Proposal Request

Architect's Project Number: 993A
Proposal Request Number: 088R
Proposal Request Date: 10.14.2024

Revisions to Dean's Office Area

Revised drawings in PR 088 updated per request for an additional secure door on level 4 in Dean's office area. PR 088R revised sheets are marked in red and include updated revision clouds.

1 TECHNOLOGY - LEVEL 4 PLAN - AREA A
1/8" = 1'-0"

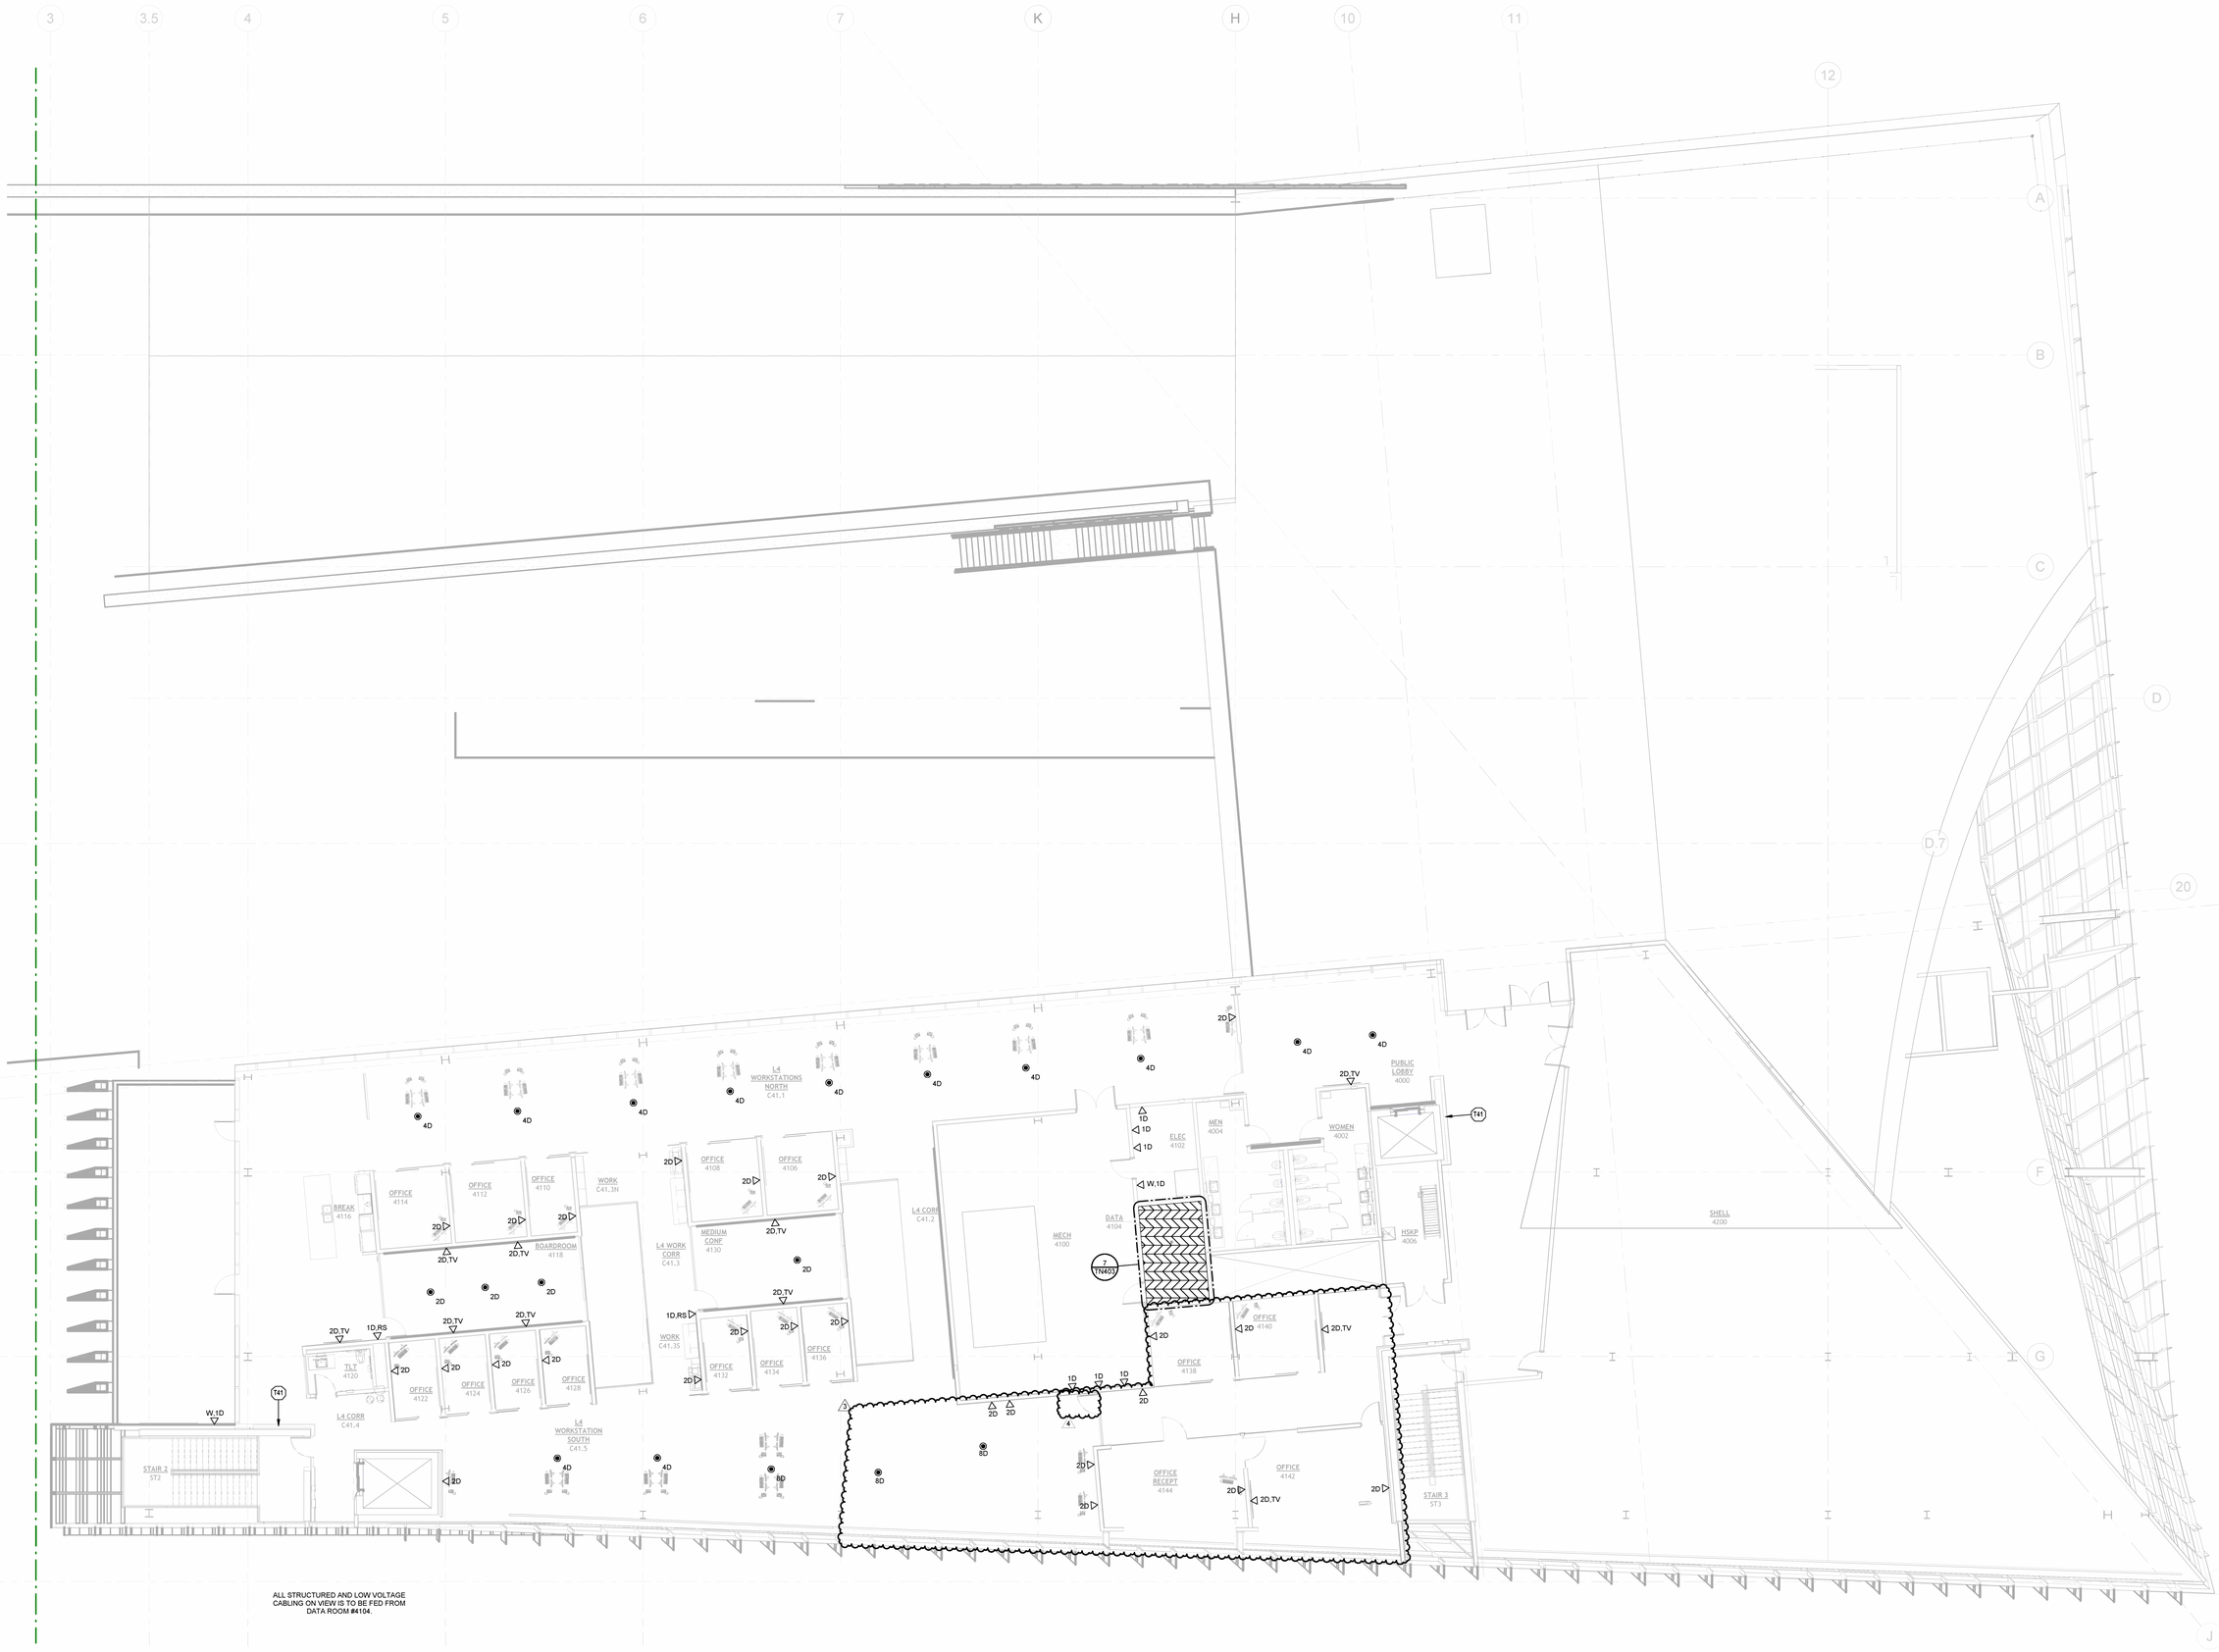
a) Refer to Revised Sheet **TN104A,** Detail **1**, with original issue date 02.24.2023 and revised date 10.07.2024.
- Remove two data outlet locations to coordinate with added door.

1 SECURITY - LEVEL 4 PLAN - AREA A
1/8" = 1'-0"

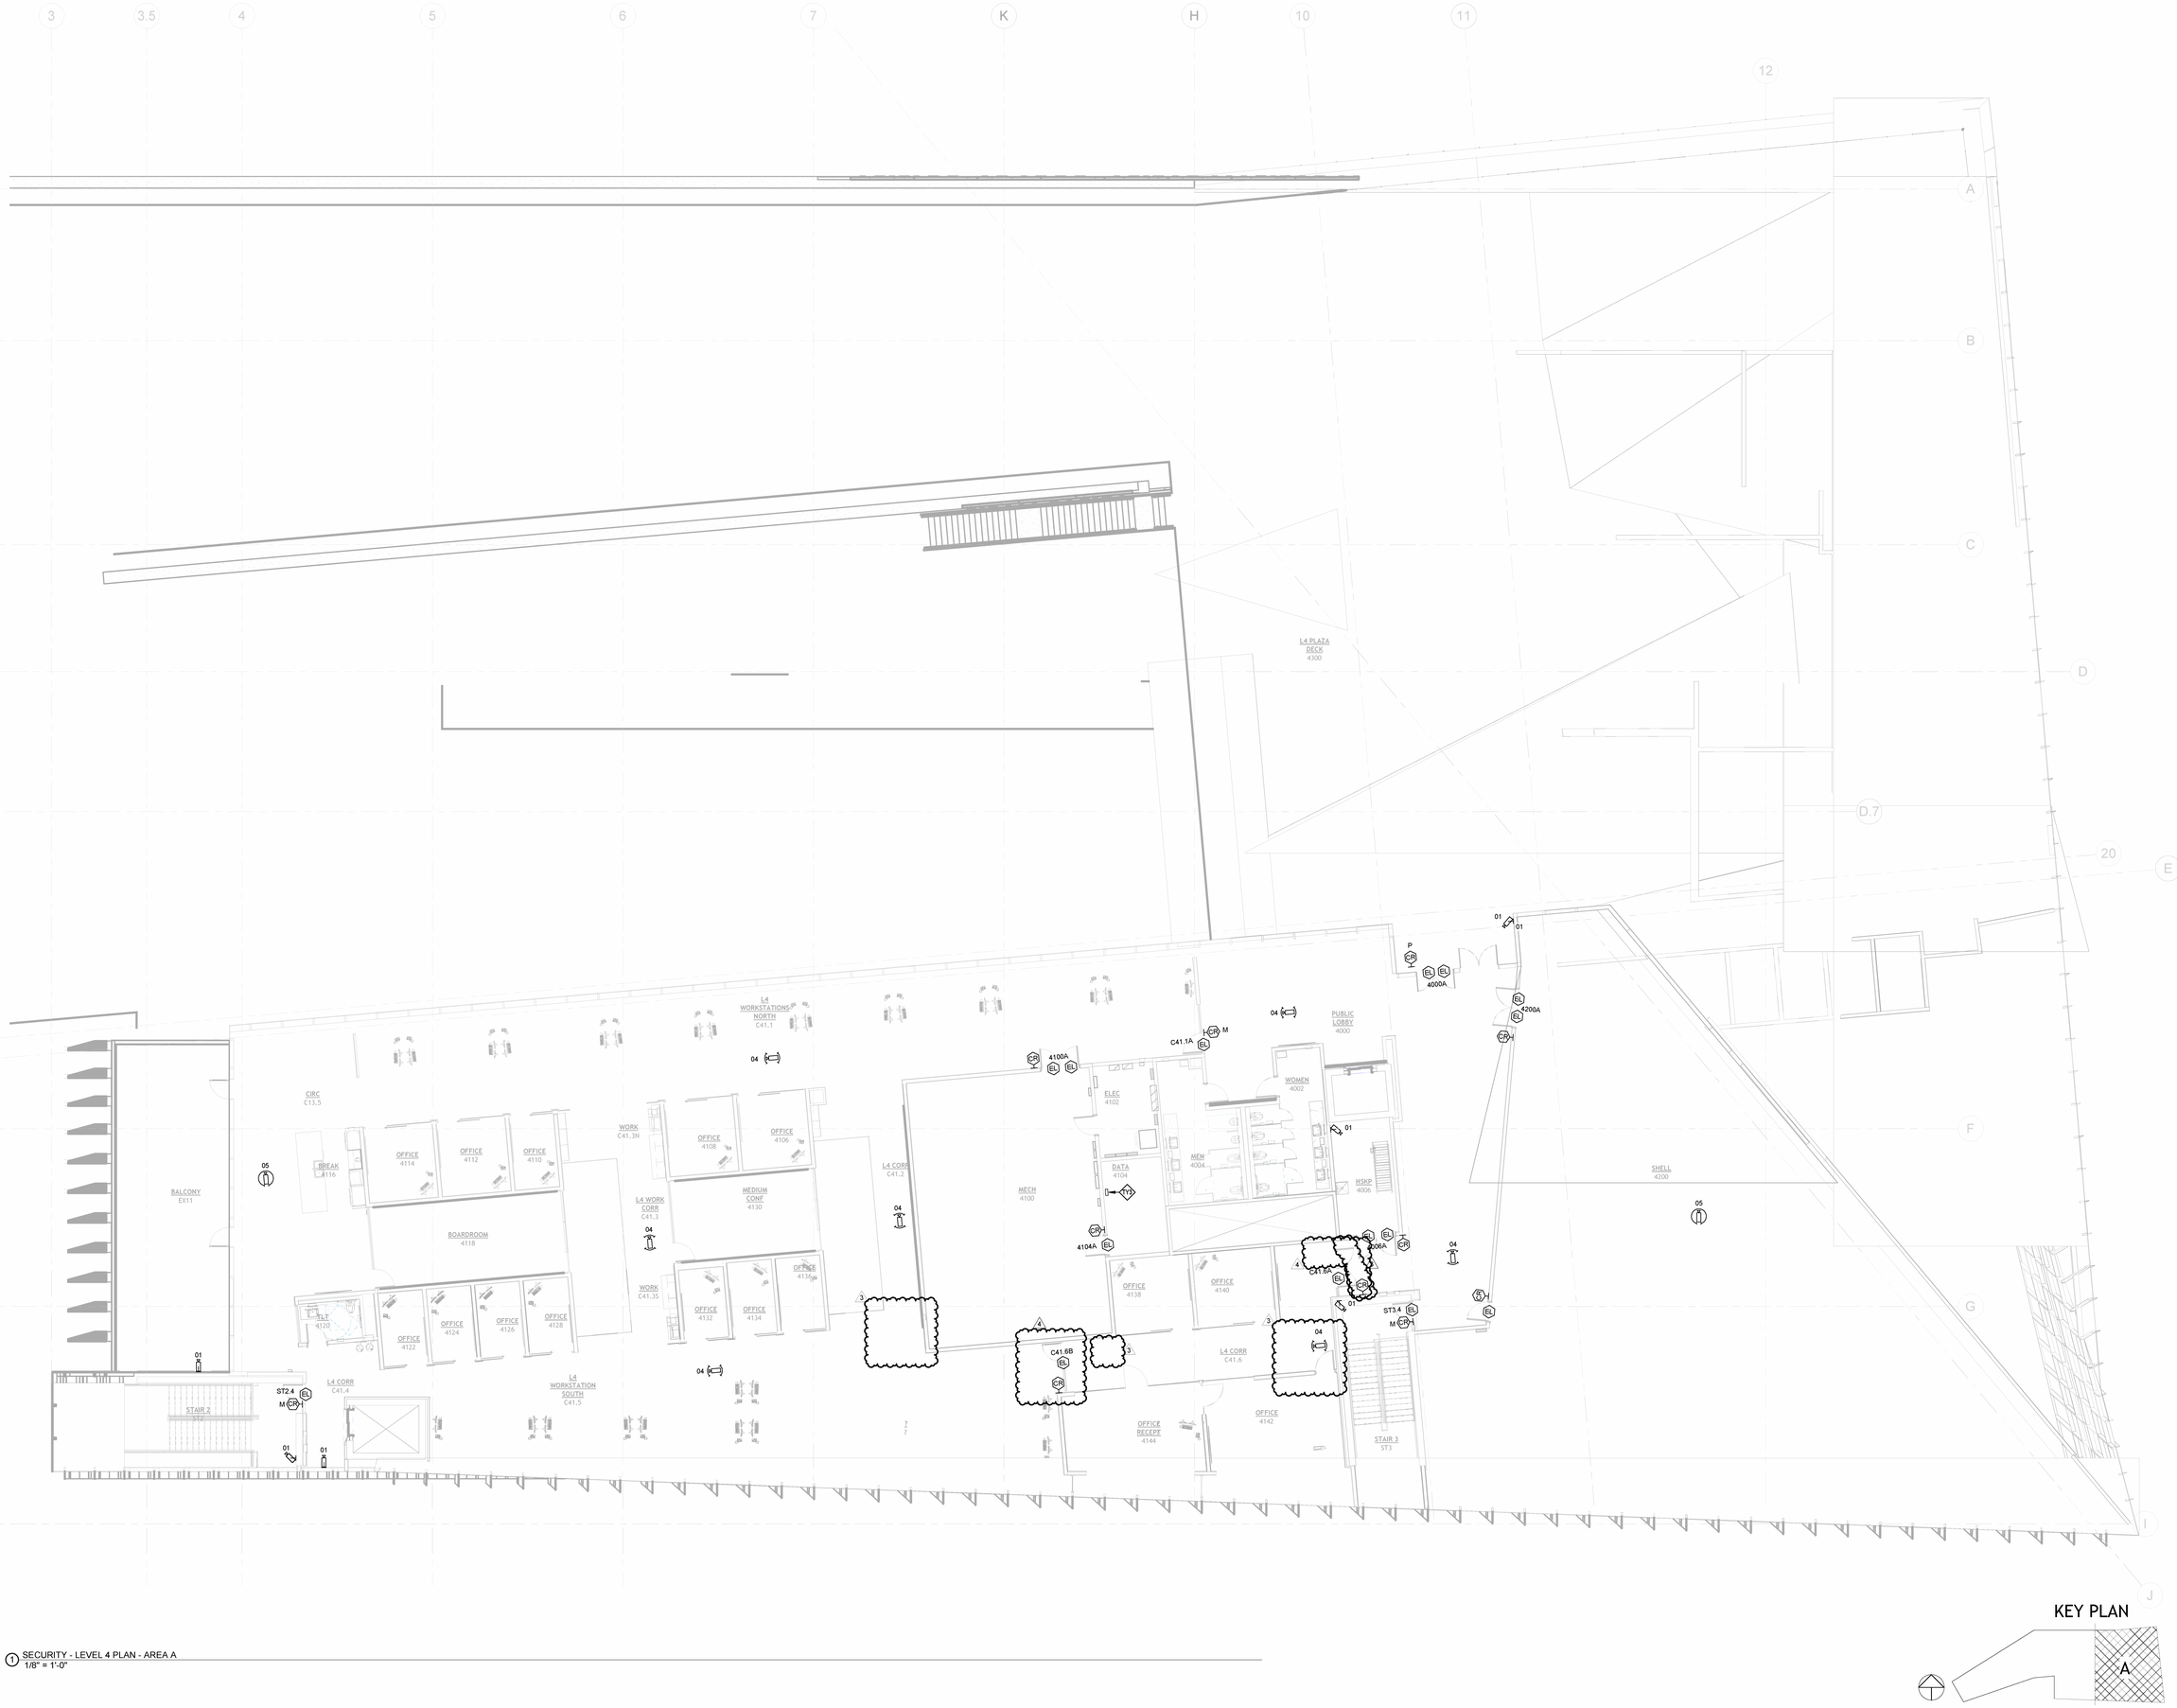
a) Refer to Revised Sheet **TY104A,** Detail **1**, with original issue date 02.24.2023 and revised date 10.07.2024.
- Add card reader to new secure door.
- Relocate card reader to match architectural locations.
